NASA/TM-2005-000000/Version 1.0  
NESC-RP-05-82/05-010-E

# NESC Peer-Review of the Flight Rationale for Expected Debris Report

**July 7, 2005**

**Figure 10.1-1. ET Tank Foam Area and Foam Debris Analysis Methods**

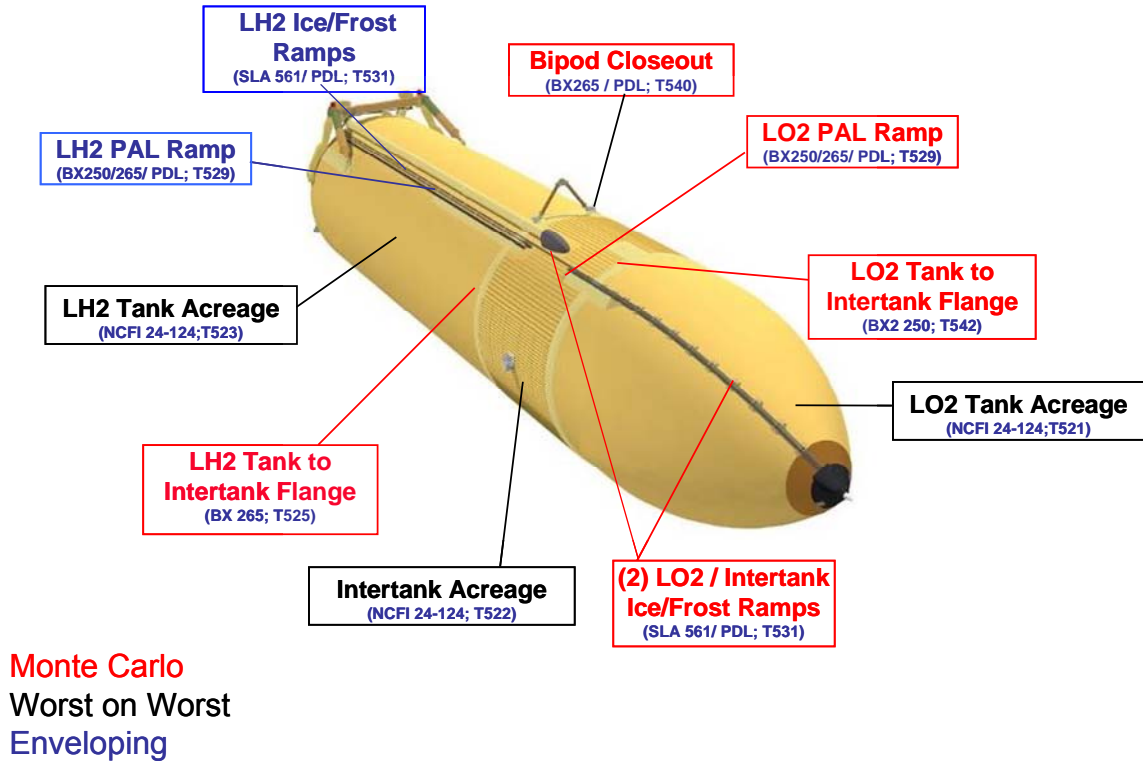
The Aerospace Corporation Monte Carlo analysis identified the most likely contributor to foam-induced damage as the ice/frost ramps. However, the model predicted divoting at a much higher rate than had been previously documented from the ET separation photographs (only a single 3-4 inch divot was identified in 161 post-ET-82 ramps that were imaged). Therefore, a review of the ET separation photos for ISS flights was performed by the NESC. Figure 10.1-3 shows the foam loss from ramps 5-9 for STS-100. The figure contains circles scaled to 1, 2 and 3 inch diameter for size comparison. The photograph shows evidence of foam loss in the size range predicted by the Aerospace analysis. Ramps 6 and 7 each show multiple instances of foam loss.

In addition to the single large ice/frost ramp divot (out of 161 ramps imaged) previously documented, the separation photos of ISS missions show fairly frequent small (on the order of 1 to 3 inch diameter) losses of foam from the middle LO<sub>2</sub> ice/frost ramps. The rate of loss at these locations is in line with that predicted by the Aerospace Corporation in their Monte Carlo analysis. However, because the photographs show no foam loss from ramps lower on the LO<sub>2</sub> tank and on the intertank, the overall probability of not exceeding the allowable impact loads on tile is lower than that predicted by the Monte Carlo analysis. In a first order sense, the Aerospace results for tile impacts from ice/frost ramp divots are at most an order of magnitude conservative.
